Planning Report

Emerald Parkway, Phase 8 – Office Building

Case Summary

Agenda Item	2
Case Number	14-027INF
Proposal	An approximately 30,000-square-foot office building with the potential for a 20,000-square-foot expansion with associated parking and site improvements.
Request	Review and informal feedback for the potential development of an office building.
Site Location	On the north side of Emerald Parkway Phase 8, approximately 750 feet east of the intersection with Riverside Drive.
Owner	Marsha Grigsby, City Manager, City of Dublin
Applicant	Tim Kelton, Ruscilli
Case Manager	Claudia Husak, AICP, Planner II (614) 410-4675 chusak@dublin.oh.us
Planning Recommendation	Discussion and Feedback

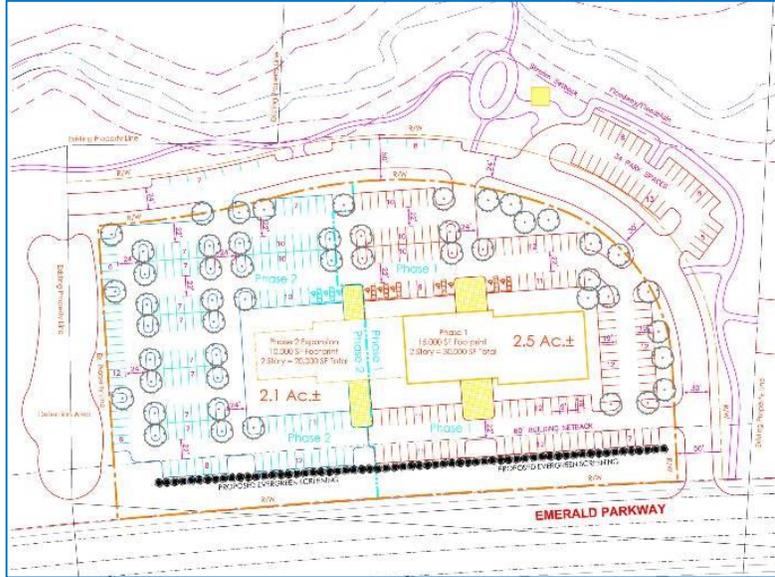
The Bright Road Area Plan emphasizes the importance of high quality development and the establishment of a visible gateway into the City of Dublin. Given the site's location near existing residences buffering the proposed office use will be an important consideration as will be the proposed character of the office building. The plan suggests the incorporation of additional open space near existing neighborhoods to facilitate pedestrian connections and park opportunities.

The Plan encourages high quality office development along Emerald Parkway that focuses on quality architecture and site design that complements the surrounding natural environment and residential neighborhoods. The Plan further emphasizes the preservation of key natural features and historic sites.

The completion of Emerald Parkway will be a significant milestone for Dublin providing relief to I-270 and providing full access from Tuttle Crossing to the south to Sawmill Road on the north. Completion of this last

phase will provide more transportation options east of the Scioto River, while allowing greater access to area neighborhoods and an expected reduction in through traffic on other local roads.
